Development Services Department
Staff Recommendations Concerning Required Findings

Project: 4213 Waters Edge Cove Bulkhead

Ordinance Standard: LDC 25-8-368(D)2

Variance Request: Approval for their newly construction bulkhead which is wider than allowed by code.

CONCRETE HEADWALL SECTION DETAIL 01

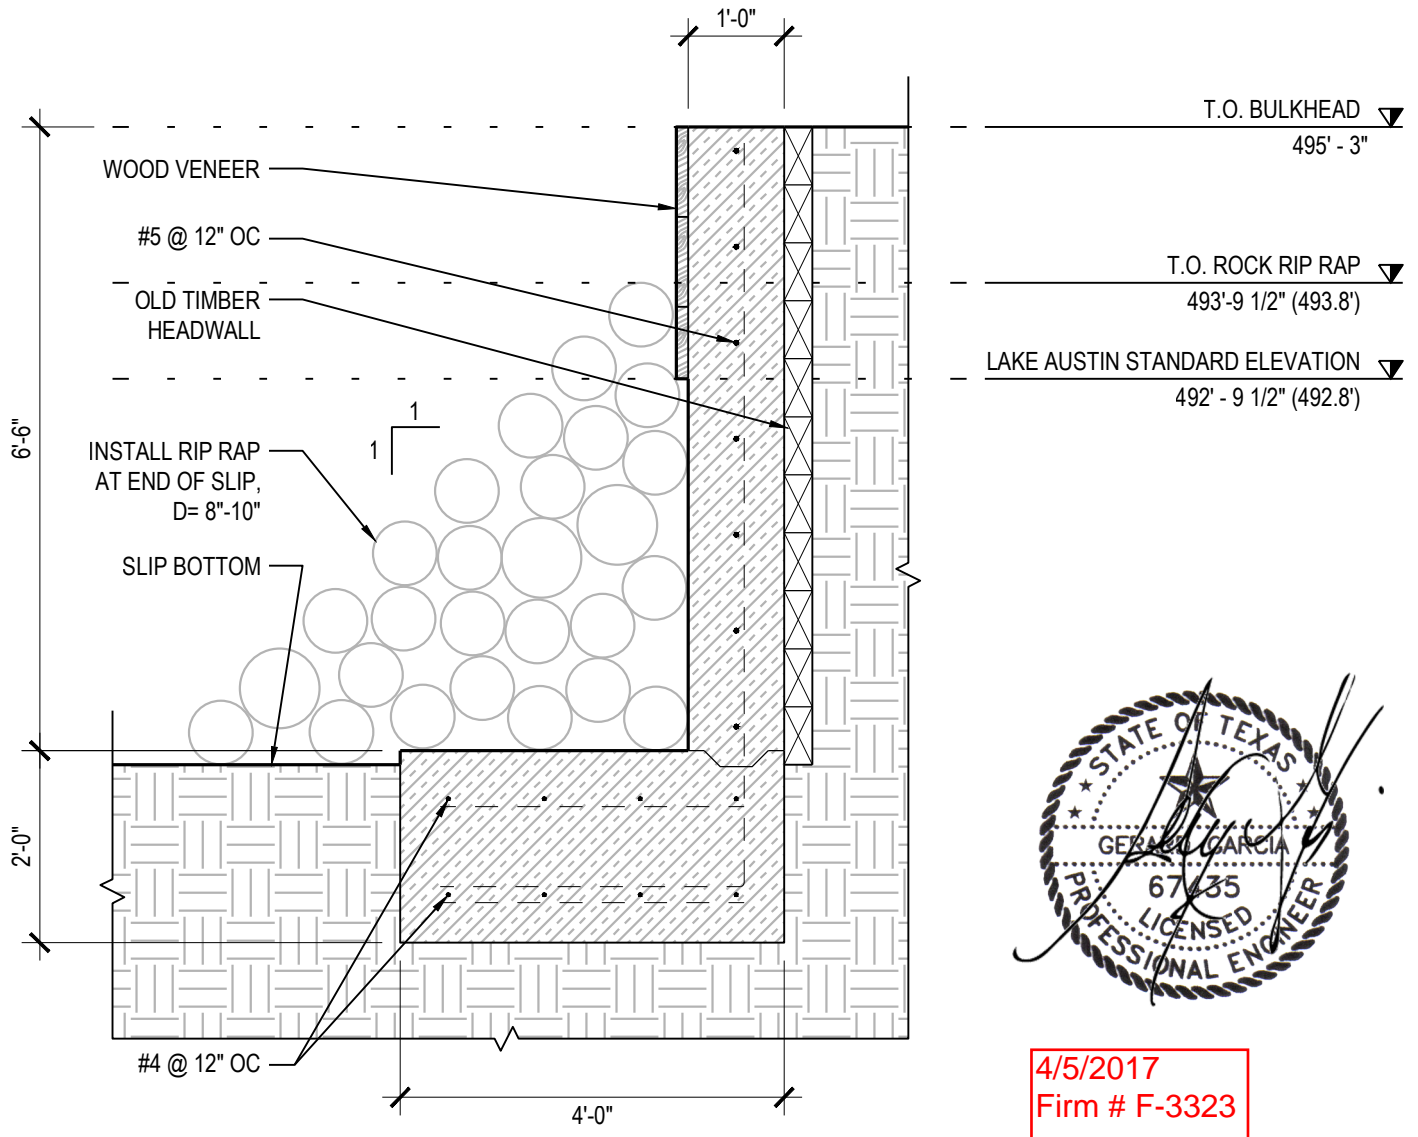
Yes / No Yes. Because of the existing boat dock impeding full site access and a structural requirement for the concrete bulkhead to be 12" instead of the code-required 6", the now as-built condition was the only option available to achieve protection of the boat slip, yard, and potentially part of a home upon finding their existing bulkhead was failing.

Yes / No Yes. The existing boat dock impeded access to the site for installation of sheet piling, so the next option was pouring concrete. To ensure structural integrity, the concrete wall needed to be wider than a sheet pile wall.

Based on the required height of the bulkhead (approximately 6.5 feet) and the lateral loads induced, structural requirements dictated a 12" thick wall. A 6" concrete wall was found not to be structurally sufficient.

The option of a sheet pile installation was not considered as the existing overhang of the boat dock roof did not allow for proper access for pile driving equipment.
